RE: *Design Exception #07-07, Panorama Terraces
TEDS Exception for Private Drive Extension*

DESIGN EXCEPTION REQUEST 07-07

Project: Panorama Point

Re: Panorama Point
REQUEST FOR TEDS EXCEPTION
Shared Drive Extension

PANORAMA TERRACES SUBDIVISION

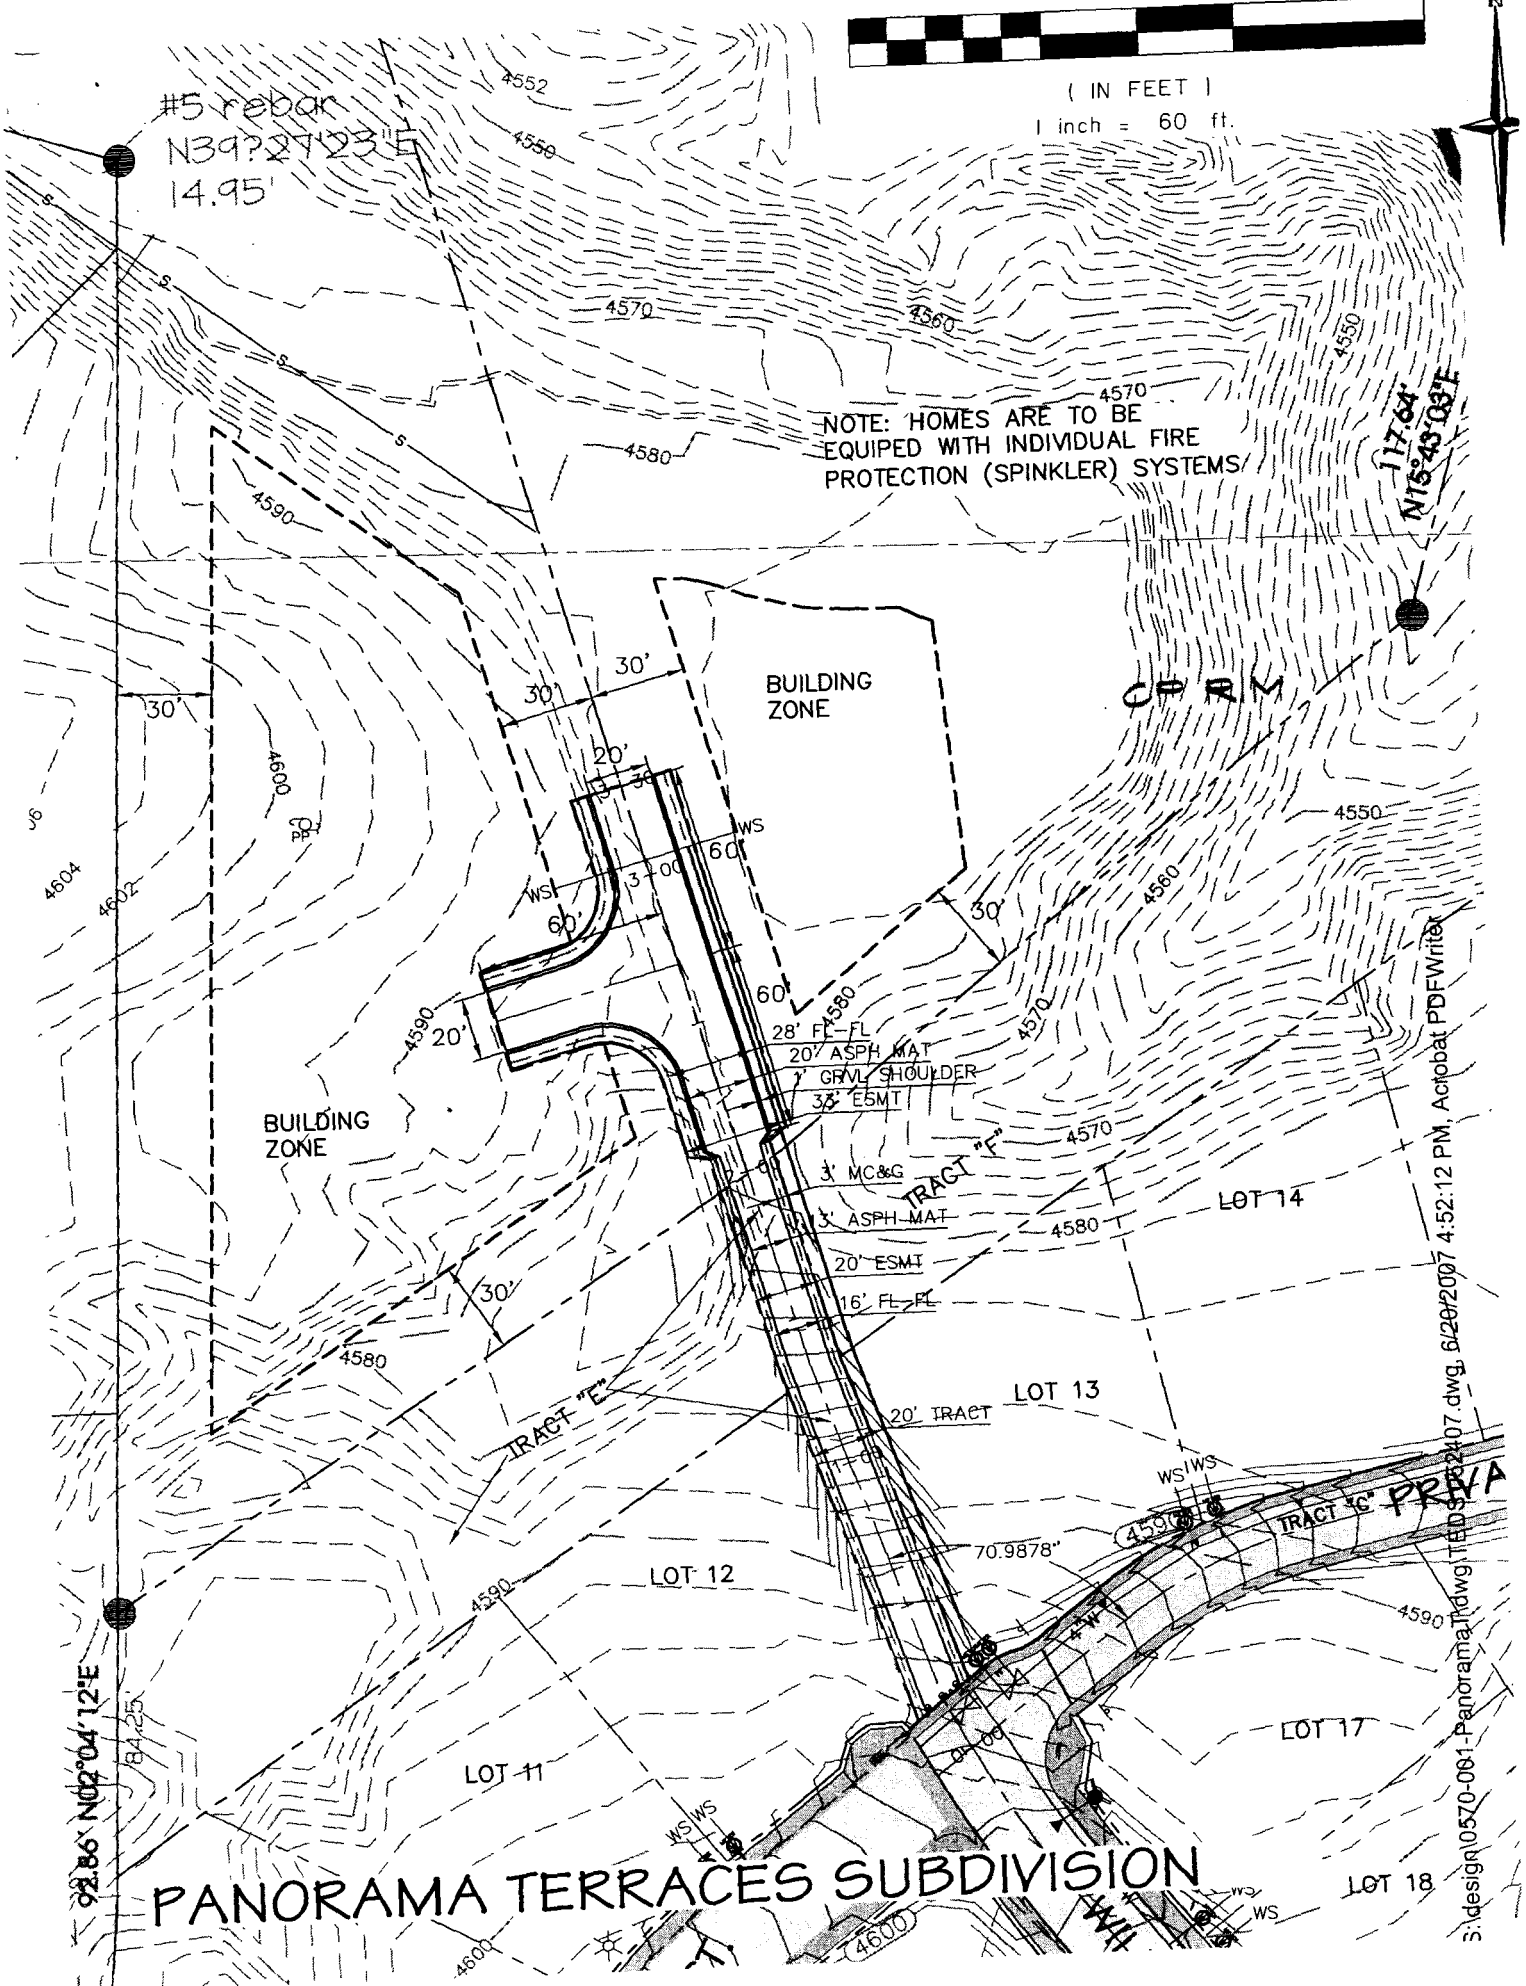
1. Need a new drawings showing building envelopes at or near the hammerhead.
2. Not more than two lots ever.
3. The old lagoon parcel goes away.
4. The distance from the fire hydrant to the center of the building envelope on the shared driveway edge needs to be 250' or less.

The applicant has agreed to these requirements and submitted a new drawing to support them. Additionally, the 250' from the fire hydrant to the center of the building envelope couldn't be attained due to problems with a private fire line and Ute Water. Consequently, they will be sprinkling the houses. This variation was approved by both Lisa Cox and Jim Bright.

NOTE: HOMES ARE TO BE
EQUIPPED WITH INDIVIDUAL FIRE
PROTECTION (SPINKLER) SYSTEMS

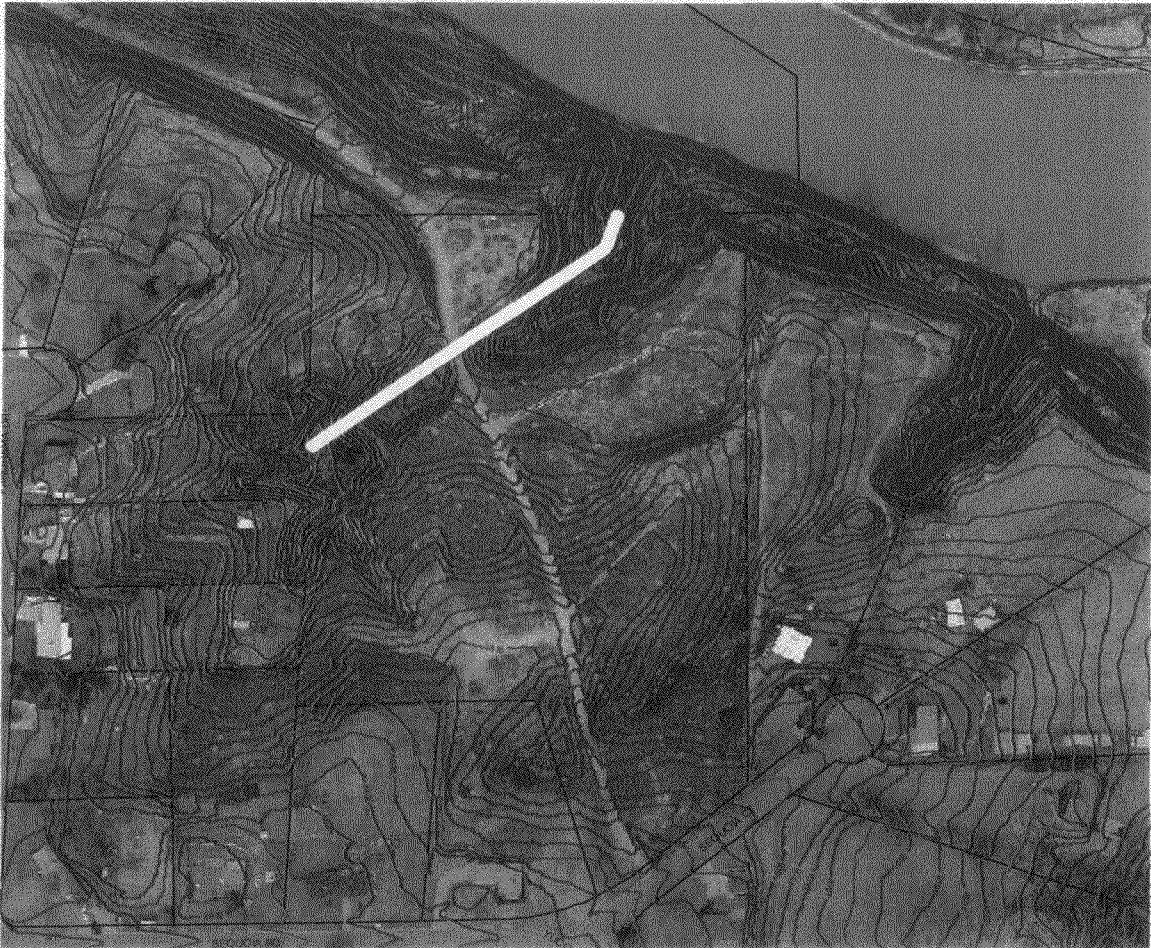
As stated above, the parcel is a remote piece on the rim above the river and behind a new County subdivision. The picture below shows the area with the approximate boundary between the Panorama Terraces Subdivision and the subject parcel drawn in. The site plan in the applicant's package shows the lot and street layout for the north portion of Panorama Terraces, the two proposed lots for their subdivision, and the shared driveway.

#1 Shared Driveway Length: The proposed shared drive would be approximately 300' long instead of the maximum 150' long.

Staff recommends approval of the exception as modified.

- Provide a fire hydrant with proper fire flow at the end of the shared driveway.
